# Leland Reservoir Replacement Project Final Environmental Impact Report

## Volume III – Responses to Comments

SCH #2016082082

Volume III

LELAND RESERVOIR | SIGHT LINE DIAGRAMS  
 EAST BAY MUNICIPAL UTILITY DISTRICT  
 1048 LELAND DRIVE | FINAL EIR - 15 YEAR PROJECTION  
 JULY 2018

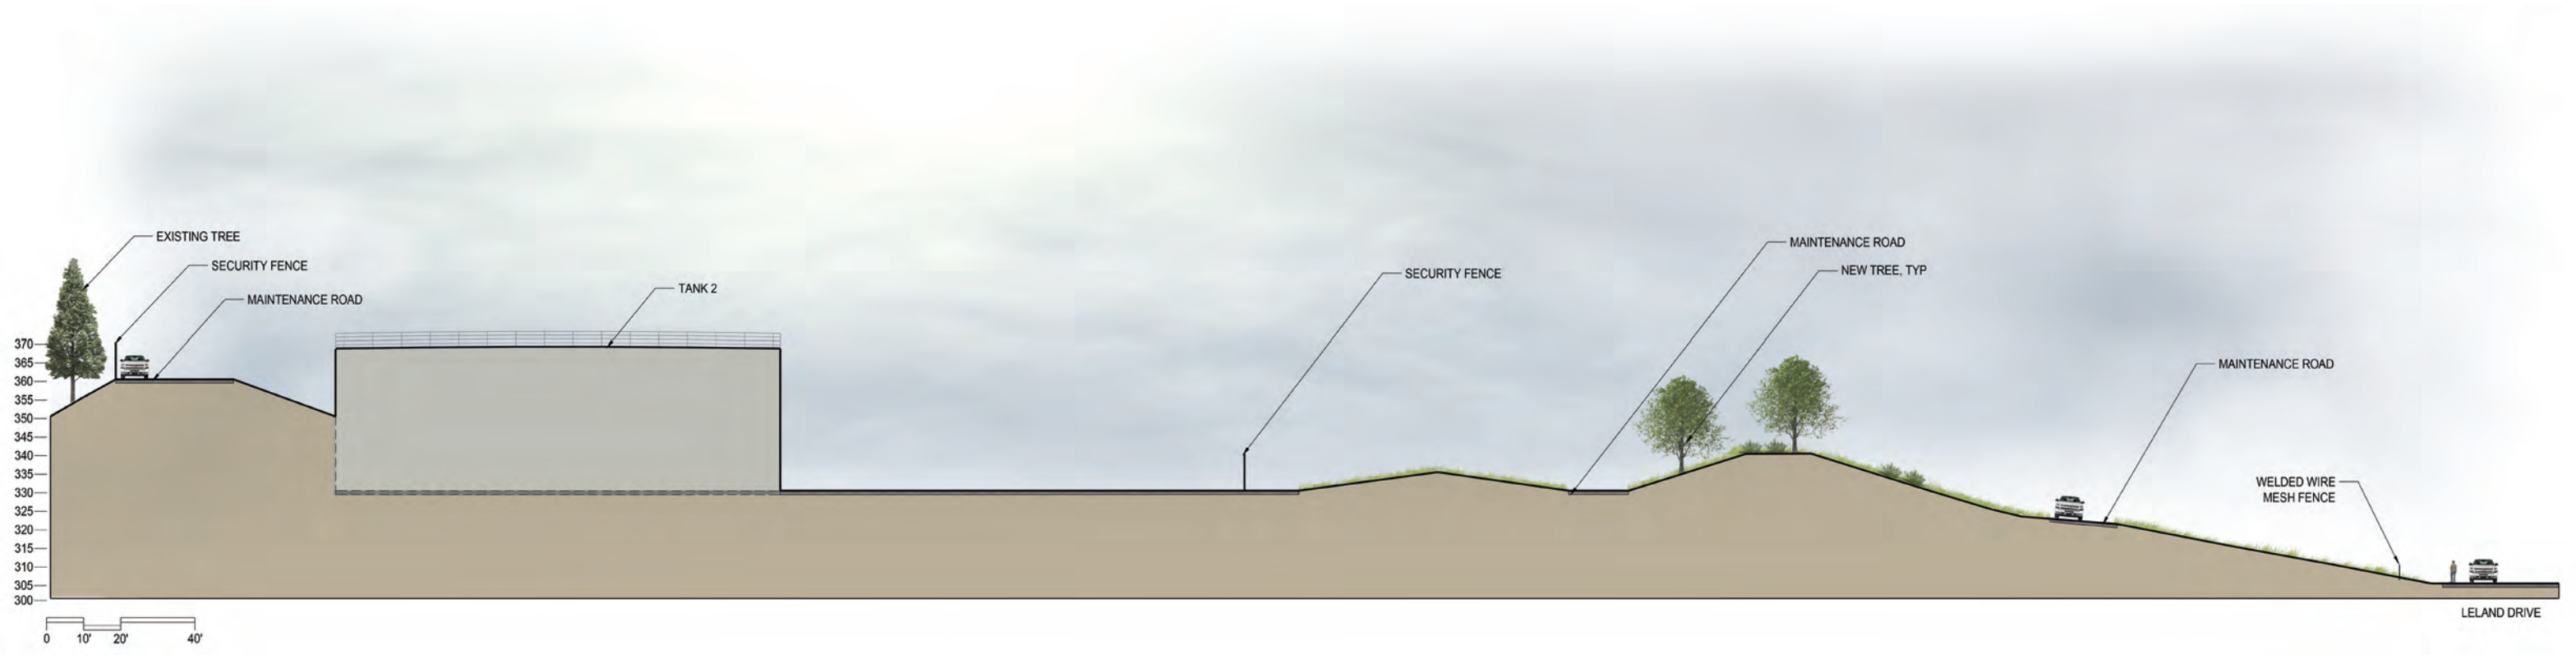
Comments have suggested that there would be a 280-foot wide valley in the middle of the existing embankment that would be visible from Leland Drive; however, no such view would exist. The access gate into the basin would not be visible from Leland Drive, and because the reservoir basin would be screened by topography, and plantings of new shrubs and trees, the new tanks are not expected to be highly visible from Leland Drive. Please refer to the end of this Master Response starting on page 9-9 for visual simulations that show the reservoir from several viewpoints, including three different angles from homes on Leland Drive to the east of the site. The visual simulations presented in this Master Response include Project conditions from immediately after construction to fifteen years after construction, and fully document the projected visual impacts of the new tanks and demonstrate that the entire height of the tanks would not be visible from Leland Drive.

In addition to the updated visual simulations, sight-line diagrams have been prepared for each of the three Leland Drive viewpoints listed above (three viewpoints on Leland Drive) and is included at the end of this Master Response starting on page 9-41. The sight-line diagrams illustrate a “slice” from each viewpoint through the Leland Reservoir site and demonstrate how topography and landscaping would screen the tanks. The location of each slice is shown on a site plan; note that the locations were selected to depict low-points in the topography where the tank would be most visible from nearby viewpoints. Because the slices do not go through the center of the tank, the full diameter of the tank is not shown.

At no time after construction would there be views from Leland Drive into the interior of the reservoir basin; the tanks would always be substantially screened from public viewpoints by topography. Sight-line diagrams presented at the end of this Master Response (pages 9-41 through 9-58) also demonstrate how topography of the post-construction embankment would substantially screen the tanks from view. Only the top of the tanks would be visible immediately following construction and the tanks would be screened by vegetation, which would almost totally hide the tanks within five years following construction.
